Access Compliance Report Public Rights-of-Way (Curb Ramps)

Intersection ID: 29119	Main Street: CRISP_WOOD_LN	Cross Street: HIGHLAND_PARK_DR	Location: S
ADA ID: 9A2DF6CD6885	Ramp Type: PerpDiag	Initial Pass/Fail: Pass	Overall Compliance: No Severity Score: 6.75

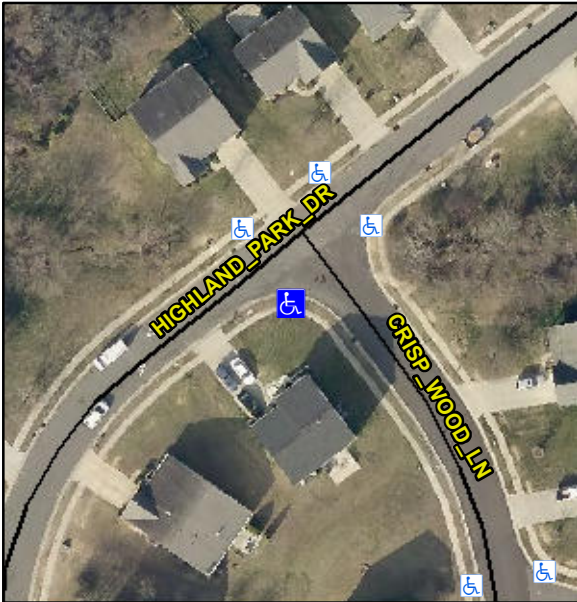
Not Found, R304.5.3, R304.2.1, R304.2.2-Perp, R304.3.2-Para, R305.1.4

Compliance	Description	Data	Compliance	Description	Data
N/A	Ramp Length (in)	47.0	Yes	Ramp Slope (%)	5.4
Yes	Ramp Width (in)	48.0	No	Ramp XSlope (%)	2.6
N/A	Flare Type LT	Sloped	N/A	Flare Type RT	N/A
N/A	Flare Slope LT (%)	3.5	Yes	Flare Slope RT (%)	0.3
N/A	Flare Traversable LT?	Yes	N/A	Flare Traversable RT?	Yes
No	Landing Length (in)	46.5	Yes	DWS Provided?	Yes
No	Landing Width (in)	47.5	Yes	DWS Contrast?	Yes
No	Landing Slope (%)	3.1	No	DWS Length (in)	23.0
No	Landing X Slope (%)	3.3	No	DWS Full Width?	No
N/A	Landing Curb? (Y/N)	No	Yes	DWS Offset (in)	2.0
N/A	Shared Landing?	No			
Yes	Gutter Ponding?	No	Yes	Gutter Slope (%)	3.6
Yes	Gutter Lip Ht (in)	0.0	Yes	Gutter X Slope (%)	1.2
N/A	Painted X Walk1?	No	N/A	Painted X Walk2?	No
	X Walk 1 Direction	To NE		X Walk 2 Direction	To NW
N/A	X Walk 1 Width (in)	N/A	N/A	X Walk 2 Width (in)	N/A
	X Walk 1 Slope (%)	1.8		X Walk 2 Slope (%)	0.5
	X Walk 1 X Slope (%)	0.9		X Walk 2 X Slope (%)	2.1

Remove & Replace Curb Ramp With Two New Directional Ramps or Equivalent.
